FACIL: 50-269 Oconee Nuclear Station, Unit 1, Duke Power Co.      05000269

SUBJECT: Forwards supplemental info requested in NRC 821122 & 29  
telcons re standby shutdown facility. Fire in one fire zone  
will not cause loss of primary inventory.

OCONEE SER QUESTION 4-ADDENDUM TO OUR ANSWER

# SSF POWER & CONTROL CABLE ROUTING

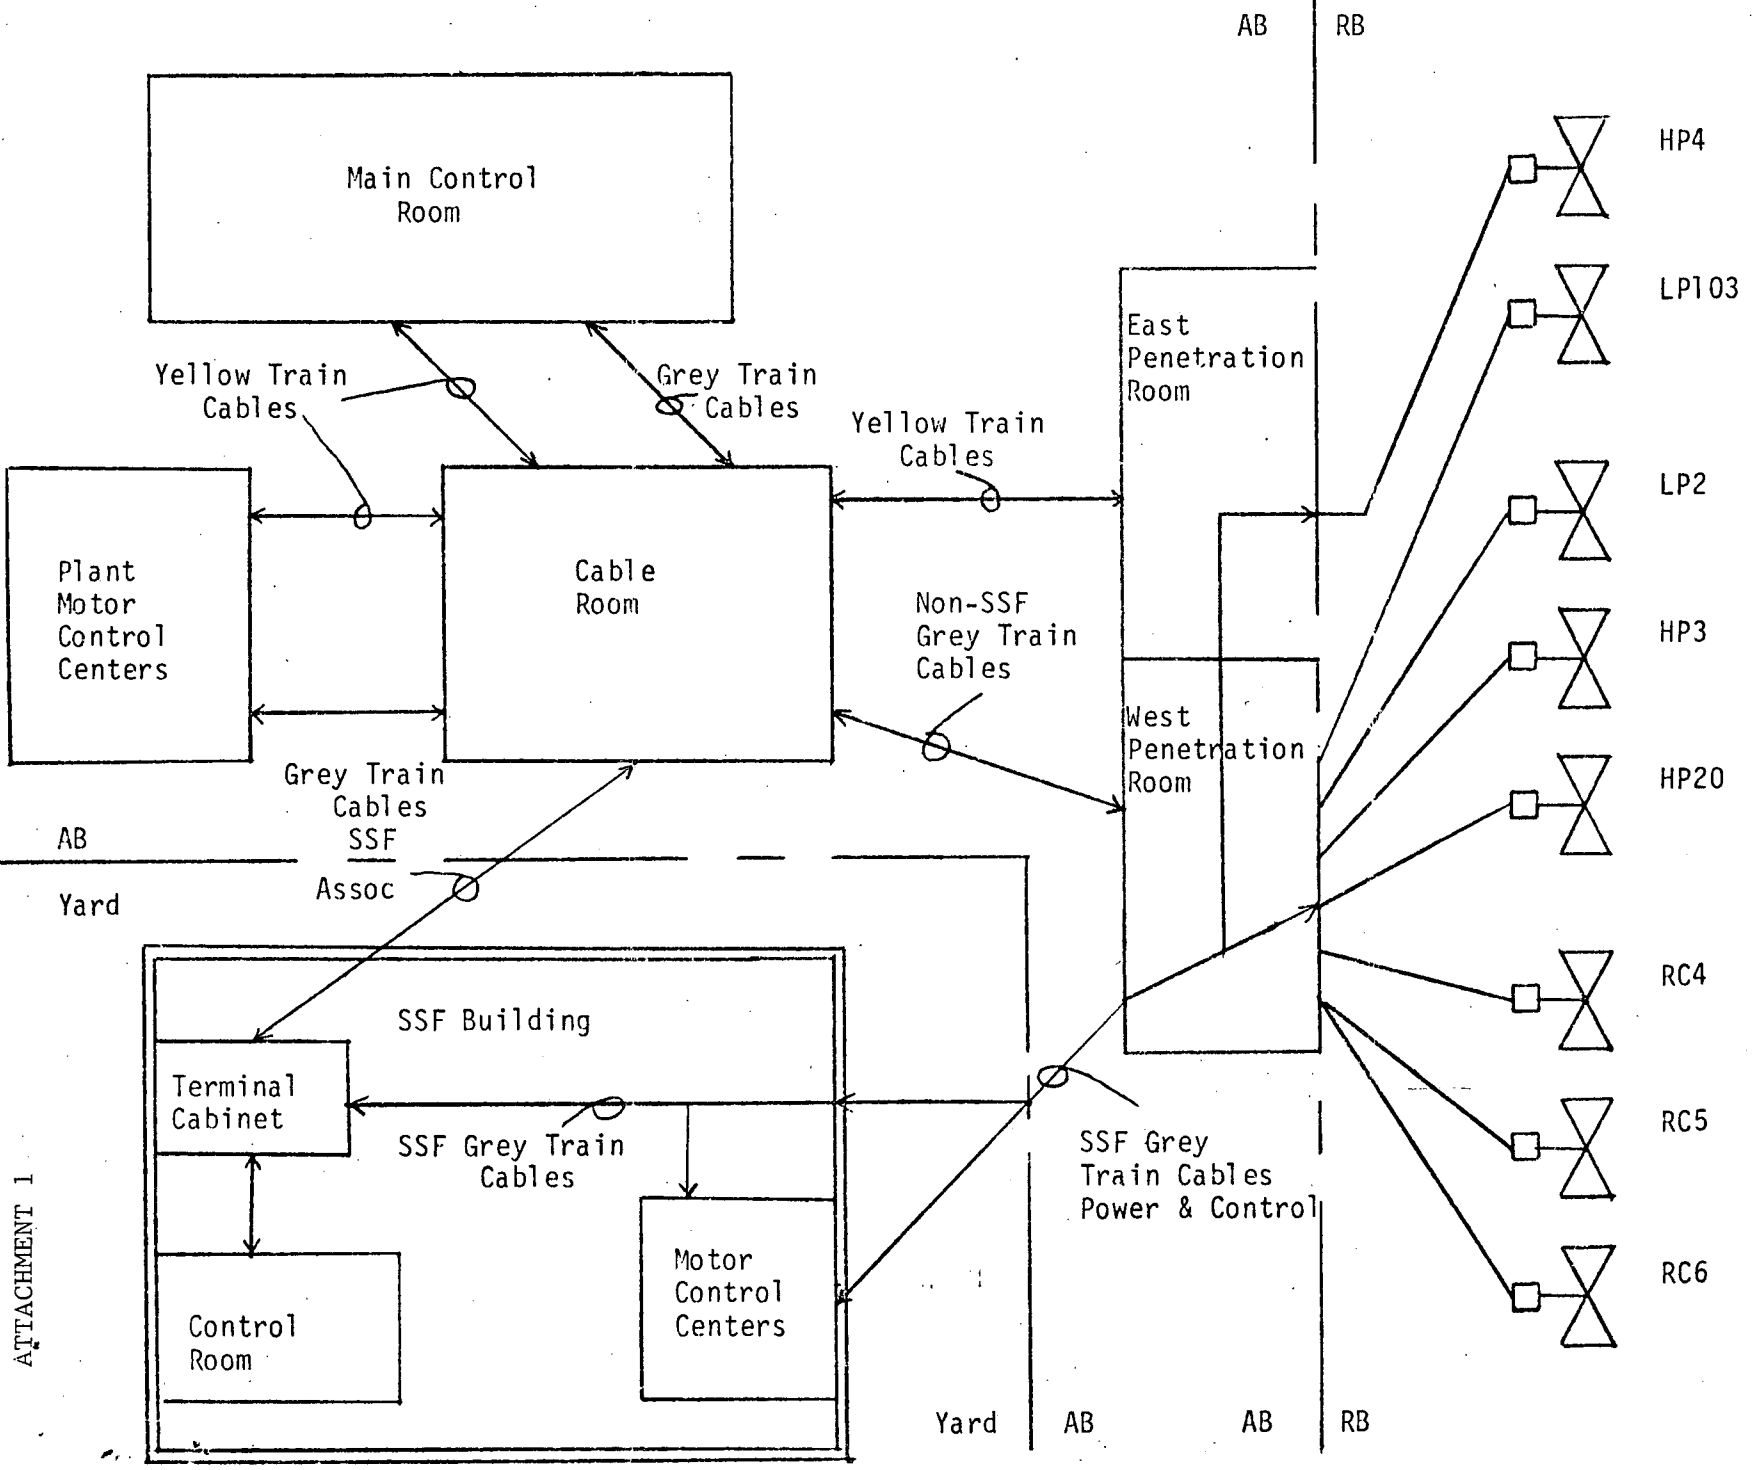
The Motor Control Centers for the primary boundary "Grey train" valves listed in our March 28, 1980 submittal are located in the Standby Shutdown Facility. Control for these valves can be from the Main Control Room during Normal plant operation or from the SSF Control Room during an SSF event. Transfer of the controls between the Main Control Room and the SSF Control Room takes place within the Standby Shutdown Facility. The "Yellow train" redundant valves are powered and controlled from the Main Control Room via the East Penetration Room into containment. Spurious operation due to a fire in any one fire zone can therefore be addressed as follows (Reference attached sketch for cable/fire zone clarification):

A. Valves HP3 (Letdown Cooler "A"), HP4 (Letdown Cooler "B"), HP20 (RCP Seal Return), RC4 (PORV Block), RC5 & RC6 (Press Stm & Wtr Sample), located in containment, receive power and control via cabling in the following manner. Power - from SSF Motor Control Centers via cabling to the West Penetration Room into containment.\* Normal power is from the incoming plant 4KV feeder and Emergency power is provided by the SSF Diesel Generator.

- a) from the Main Control Room, control is achieved via cabling to the cable room through the cable spreading room to the relay transfer cabinet in the SSF. From the transfer cabinet via the West Penetration Room into Containment.\*
- b) from the SSF Control Room, control is achieved via cabling to the relay transfer cabinet (this cabinet removes all control from the Main Control Room, transferring control to the SSF Control Room) through the West Penetration Room into containment.\*

\* HP4 Routes through the West Penetration Room via conduit to the East Penetration Room into Containment.

- B. Valve LP2 (Decay Heat) has its remote starter located in the SSF with a Reactor Coolant System pressure interlock cabled from containment via cabling to the West Penetration Room into the SSF. (Pressure interlock prevents opening of valve LP2 if RCS pressure is greater than 400 psig). Control cabling from the Main Control Room via the Cable Room into the SSF and the cabling for the pressure interlock are in the same fire zone where they become common in the SSF and the West Penetration Room.
- C. Valve LP103 (Alternate Decay Heat) has no Main Control Room controls; control is provided from the SSF Control Room only via cabling to the West Penetration into containment.
- D. The High Point Vent Valves (RC155, 156, 157 & 158), and the Reactor Head Vent Valves (RC159 & 160) have their power removed during normal plant operation or an SSF event.

Conclusion - A fire in any one fire zone will not cause a spurious operation that will cause a loss of primary inventory and disable the system necessary to provide makeup.
